Project title Knocklyon to Ballyboden Active Travel Scheme
Job number 284940-00
File reference
cc
Prepared by Jakub Radomski
Date 26 June 2025
Subject Stage 1 - Quality Audit

Stage 1 Quality Audit

Document Ref:		P24204-PMCE-XX-XX-RP-QA-3_0001			
Rev	Prepared By	Reviewed By	Approved By	Issue Date	Reason for Revision
2.0	AOR	AP	AOR	7 th January 2025	Final Report
1.0	XY	AOR	AOR	29 th Nov. 2024	Draft Report

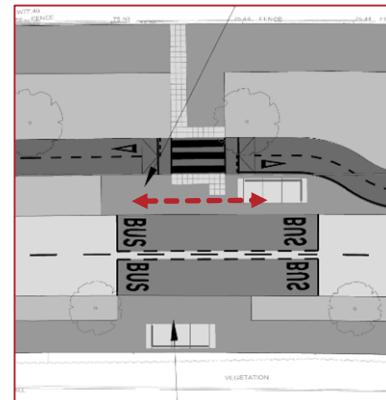
'L-shaped' red-coloured tactile paving should be provided on the footpath side of the crossings. The bus shelter may need to be relocated in some instances to facilitate the tactile paving stem.

2.5 Pedestrian Crossing Inaccessible for Visually Impaired Pedestrians

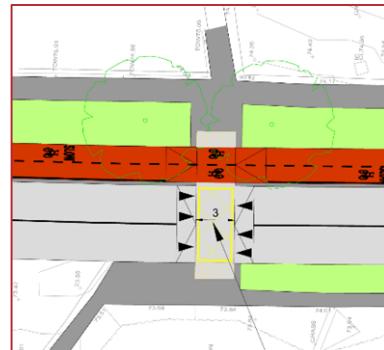
The existing uncontrolled pedestrian crossing on Templeroan Lawn, which links the footpaths on Templeroan Avenue and Knocklyon Road, is proposed to be realigned, raised, and widened to 3m. The crossing would be 9m wide in total and would require pedestrians to cross two traffic lanes and a two-way cycle track. The uncontrolled crossing would be inaccessible for, and, therefore, be unable to be used, by visually impaired pedestrians, without assistance, resulting in them being unable to independently navigate the road layout.

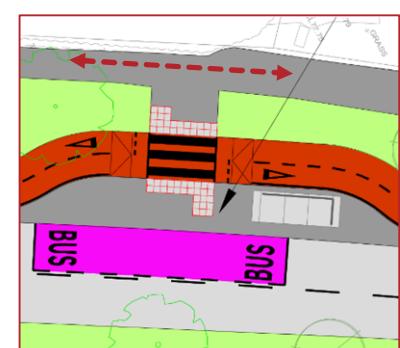
A crossing of the cycle track has been indicated at the island bus stop on Ballyboden Way adjacent to Templeroan Drive. The stem of the tactile paving on the northern side of the crossing does not extend to the rear of the footpath.

This may lead to visually impaired pedestrians continuing past the tactile paving and failing to detect the crossing, and thus the bus stop, resulting in them being unable to independently navigate the road layout.

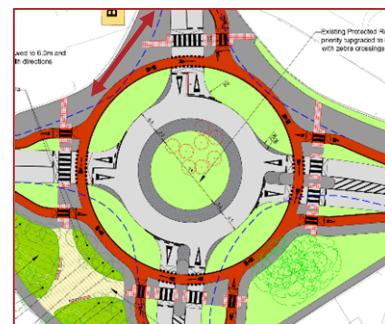
A Zebra crossing has been indicated on Ballyboden Way upstream of the roundabout junction with Ballyboden Road and Taylor's Lane. The stem of the tactile paving on the southern side of the crossing does not extend to the rear of the footpath.

This may lead to visually impaired pedestrians, approaching from the south on Ballyboden Road, continuing past the tactile paving and failing to detect the crossing resulting in them being unable to independently navigate the road layout.

2.8 Inconsistent Tactile Paving Arrangement at Existing Controlled Crossing

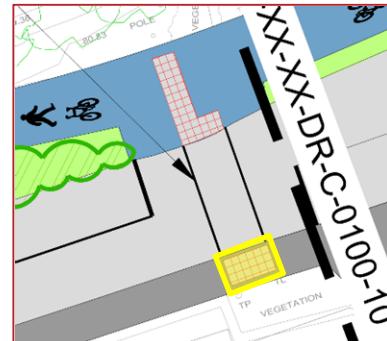
It is proposed to retain the existing signalised crossing on Knocklyon Road located to the east of the Knocklyon Shopping Centre. The tactile paving indicated on the southern side of this crossing, however, does not contain a stem and is, therefore, not the correct type of tactile paving for use at a controlled crossing. This may lead to confusion for visually impaired pedestrians or to them being unable to locate the push-button at the crossing.

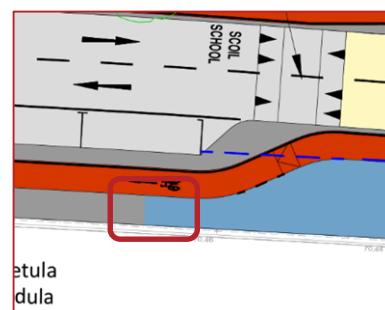
Tactile paving has not been indicated at the transitions between shared paths and segregated pedestrian and cycle facilities, or between shared paths and pedestrian-only footpaths, in all instances throughout the scheme, resulting in a lack of consistency in the tactile paving provision within the drawings.

A failure to provide appropriate tactile paving at the transitions between different non-motorised road user facilities may lead to visually impaired pedestrians being insufficiently aware that they are moving between areas that may be shared with cyclists.

During the detail design stage, tactile paving, as necessary for the type of transition and adjacent surfaces, should be provided at all necessary locations within the scheme.

3.1 Pinch-Point in Footpath

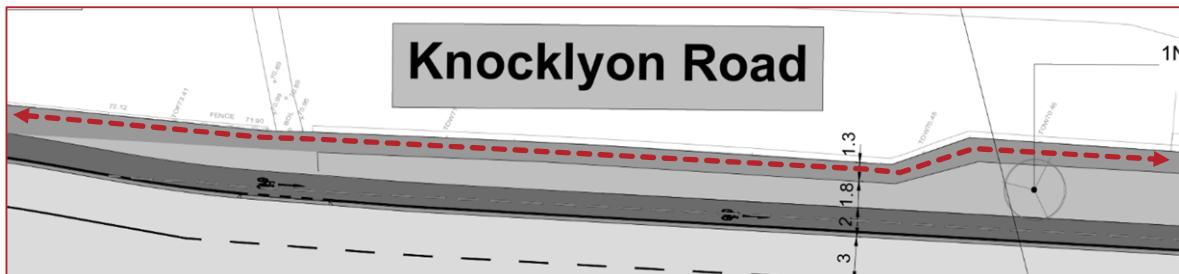
The footpath on the eastern side of Knocklyon Road opposite its junction with Delaney's Public House reduces in width at the commencement of the verge and continues with a relatively narrow cross-section for a short distance. This creates a pinch-point within the footpath which may lead to pedestrians having to enter the verge to pass opposing pedestrians.

3.3 Lack of Pedestrian Crossing

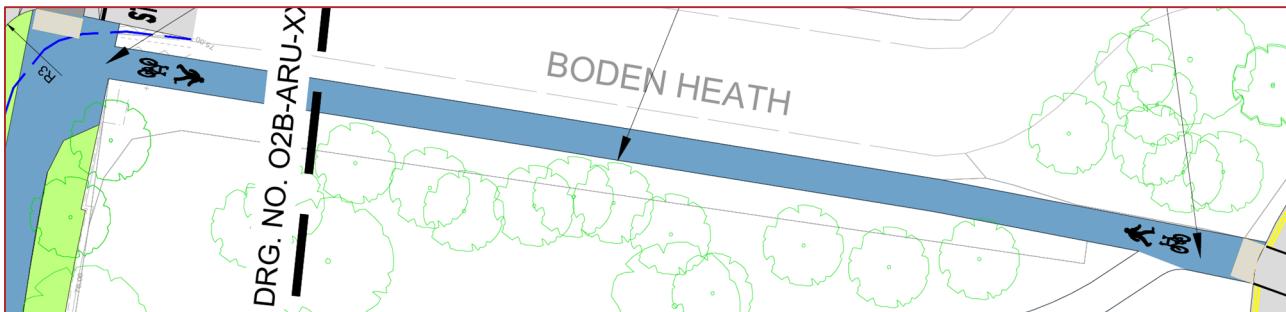
No pedestrian crossing, including associated infrastructure such as dropped kerbs and tactile paving, has been indicated across the Dargle Wood side road at its junction with Knocklyon Road. This may lead to pedestrians having to mount/dismount a full height kerb when crossing the side road resulting in difficulties, particularly for mobility impaired pedestrians.

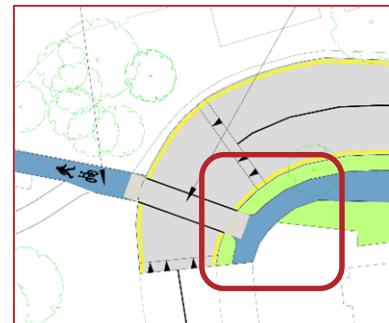
It is proposed to retain the existing footpath on the western side of Boden Heath in its current form but to convert it to a shared path and, similarly, to widen the existing footpath on the western side of Boden Park Green to 3m and convert it to a shared space.

The proposed shared paths on the western side of Boden Heath and directly adjacent to the southern side of the uncontrolled pedestrian crossing on Boden Park Green, do not appear to be wide enough such that they would sufficiently accommodate both pedestrians and cyclists.

The shared paths should be a minimum of 3m wide throughout their length.

4.1 Guardrail Blocks Cyclist Route

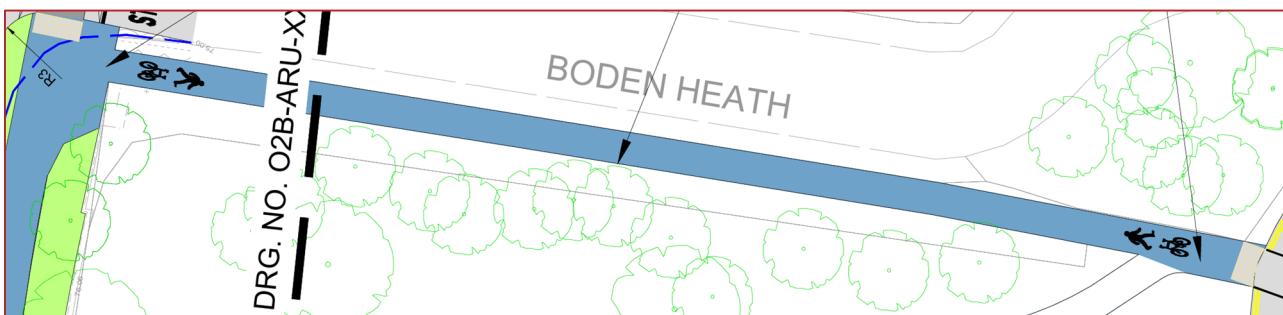
A guardrail is located at the edge of the carriageway on the western side of Knocklyon Road adjacent to Gaelscoil Chnoc Liamhna which is proposed to be retained. The guardrail is located close to the ramp from the northbound cycle track such that it may present an obstacle to cyclists, particularly schoolchildren, exiting the cycle track and entering the shared path.

4.2 Width of Shared Paths

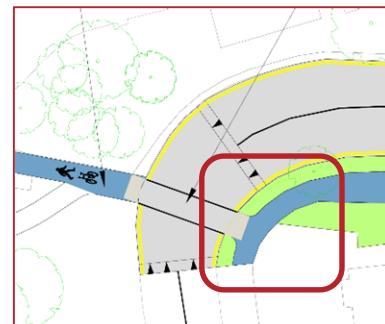
It is proposed to retain the existing footpath on the western side of Boden Heath in its current form but to convert it to a shared path and, similarly, to widen the existing footpath on the western side of Boden Park Green to 3m and convert it to a shared space.

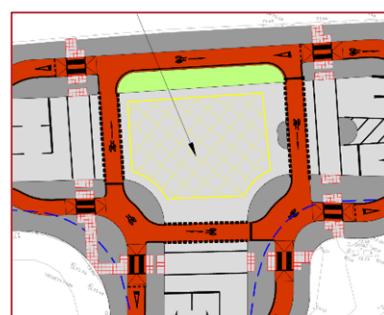
Summary: It is unclear if the reduced extents of the carriageway at revised signalised junctions and roundabouts within the scheme will safely accommodate the swept path of all vehicles.

It is, therefore, unclear if the revised road layout at junctions, and the reduced carriageway space due to the amended kerbs, will sufficiently accommodate the swept path of all vehicles where turning drivers may be restricted by the revised kerb line, for example at the Firhouse Road and Knocklyon Road junction. If drivers cannot complete turning manoeuvres within the extents of the carriageway there is a risk of kerb strikes and vehicles potentially entering the cycle lanes or mounting the footpath, increasing the risk of collisions with items of roadside furniture or with other road users.

The swept path of all vehicles should be accommodated safely at all junctions within the scheme.

Location: Drawing no. O2B-ARU-XX-XX-DR-C-0100-03 (Rev. P01)

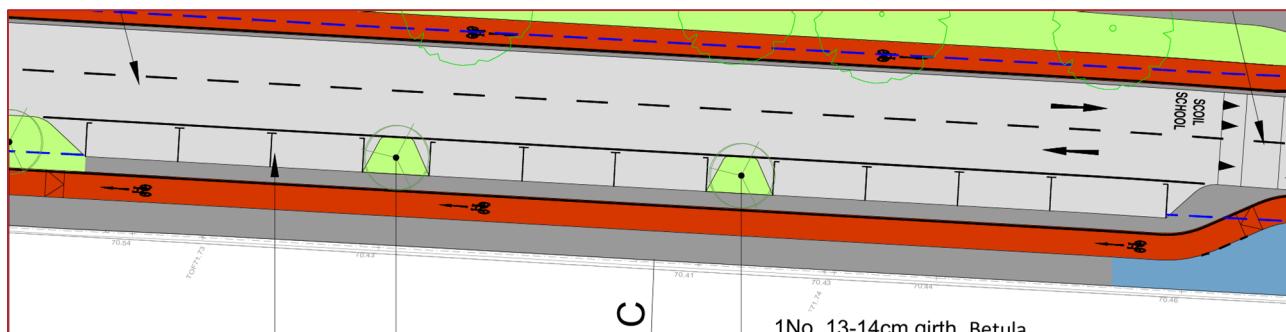
In addition, the footpath travels through two horizontal curves in quick succession within this narrow section such that the adjacent boundary hedge may restrict a pedestrian's forward visibility to oncoming pedestrians resulting in conflicts.

Location: Drawing no. O2B-ARU-XX-XX-DR-C-0100-25 (Rev. P01)

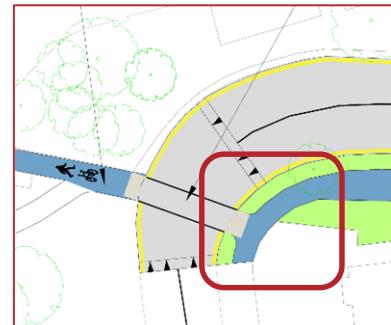
The proposed shared paths on the western side of Boden Heath and directly adjacent to the southern side of the uncontrolled pedestrian crossing on Boden Park Green, do not appear to be wide enough such that they would safely accommodate both pedestrians and cyclists which could lead to an increased risk of conflicts between these road users.

Location: Drawing no. O2B-ARU-XX-XX-DR-C-0100-28 (Rev. P01)

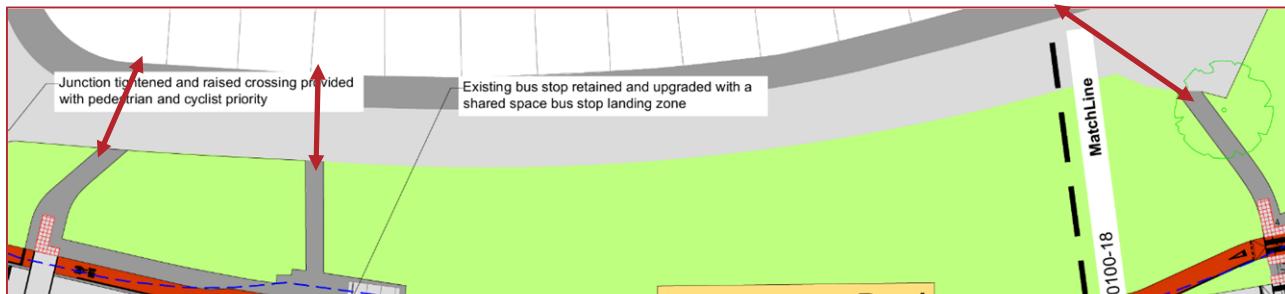
Summary: Three footpath links through the grass verge between Scholarstown Road and Scholarstown Park terminate at the Scholarstown Park carriageway with no crossings indicated to access the footpath on the opposite side of Scholarstown Park.

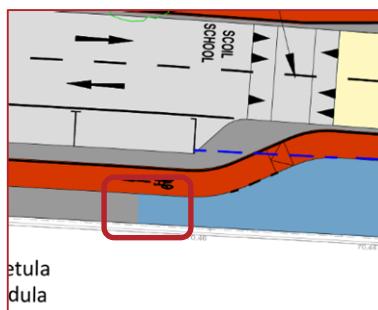
4.2 Right-turn pockets have been indicated within the cycle tracks at the proposed Toucan crossing on Knocklyon Road adjacent to its junction with Delaford Avenue and within the eastbound cycle track at the proposed Toucan crossing on Knocklyon Road at the Knocklyon Lodge Creche & Montessori. It is unclear, however, at this early design stage if push-button units for cyclists will be provided within arm's reach of a cyclist stopped in the right-turn pocket to trigger a pedestrian/cyclist phase at the crossing. During the detail design stage care should be taken to provide a push-button unit for cyclists at these crossings that can be easily reached from the right-turn pocket.

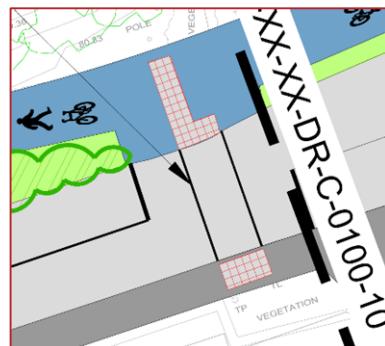
4.4 A note on drawing no. O2B-ARU-XX-XX-DR-C-0100-06 (Rev. P01) indicates that the existing footpath between the proposed Zebra crossing on Knockfield Manor and the existing signalised crossing on Knocklyon Road would be widened to 3m and converted to a shared space. The layout indicated on the drawing, however, appears to indicate a segregated footpath and two-way cycle track at this location, which contradicts the note provided. The drawing should be amended to indicate the intended road layout at this location such that the layout is consistent with the note.

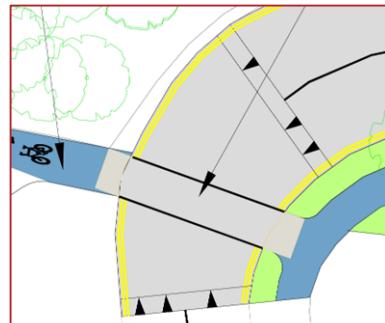
4.5 It is proposed to retain the existing signalised crossing on Knocklyon Road located to the east of the Knocklyon Shopping Centre. The tactile paving indicated on the southern side of this crossing, however, does not contain a stem and is, therefore, not the correct type of tactile paving for use at a controlled crossing. This may lead to confusion for visually impaired pedestrians or to them being unable to locate the push-button at the crossing. The tactile paving on the southern side of the crossing should include a stem on its right-hand side.

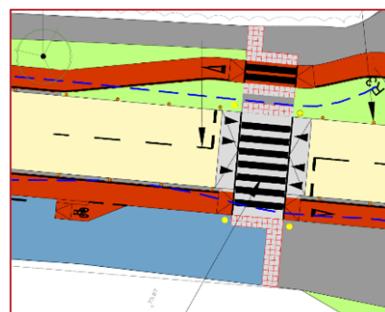
4.8 Belisha beacons have been indicated at some Zebra crossings within the scheme but not in all instances, resulting in a lack of consistency in its provision throughout the scheme. Belisha beacons should be provided at all Zebra crossings within the scheme.

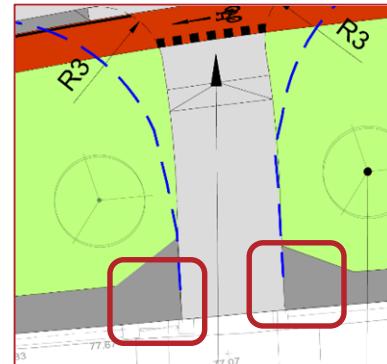
4.9 The layout of the transition between the shared path and footpath on the western side of the Zebra crossing on Knocklyon Road adjacent to Gaelscoil Chnoc Liamhna is such that there would be no obvious location where the appropriate tactile paving could be provided to advise visually impaired pedestrians of the transition between the footpath and shared path.

During the detail design stage, this location should be amended to provide hazard warning tactile paving (corduroy) within the footpath where it transitions to the shared path. This should be located such that it does not directly abut the tactile paving at the Zebra crossing.

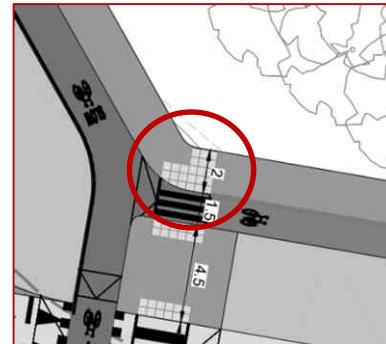
The stem of the tactile paving on the northern side of Ballyboden Way, where it intersects Templeroan Lawn at the roundabout, is indicated on the incorrect side of the crossing. This may lead to visually impaired pedestrians misinterpreting the type of crossing, or being unable to locate the crossing of the cycle track.

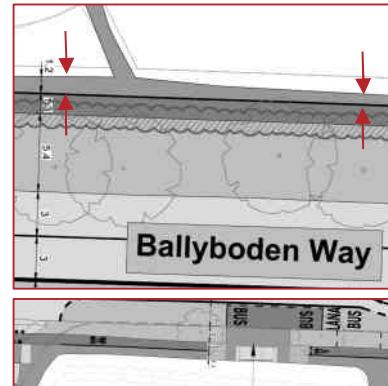
The width of the footpath indicated on the western side of Ballyboden Way to the north of its footpath connection with Templeroan Green and the eastern side of Ballyboden Way north of its junction with Templeroan Lodge is less than 1.2m, and it is, therefore, not a sufficient width for pedestrians to travel within the footpath. This could lead to wheelchair users, or pedestrians pushing prams/strollers, experiencing difficulty in travelling on the footpath.

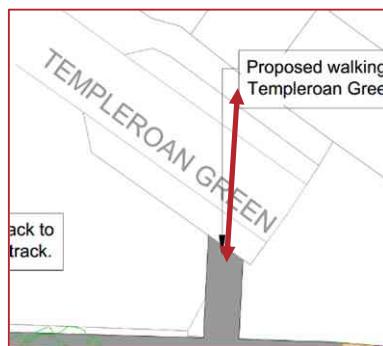
A proposed footpath link has been indicated between the footpath on the western side of Ballyboden Way and the Templeroan Green residential development. The proposed footpath link, however, terminates at the carriageway on Templeroan Green with no measures indicated for pedestrians to cross to the existing footpath on the other side of the Templeroan Green carriageway. This may lead to difficulties for pedestrians, particularly the mobility-impaired, who have to ascend/descend a full height kerb on the other side of the road.
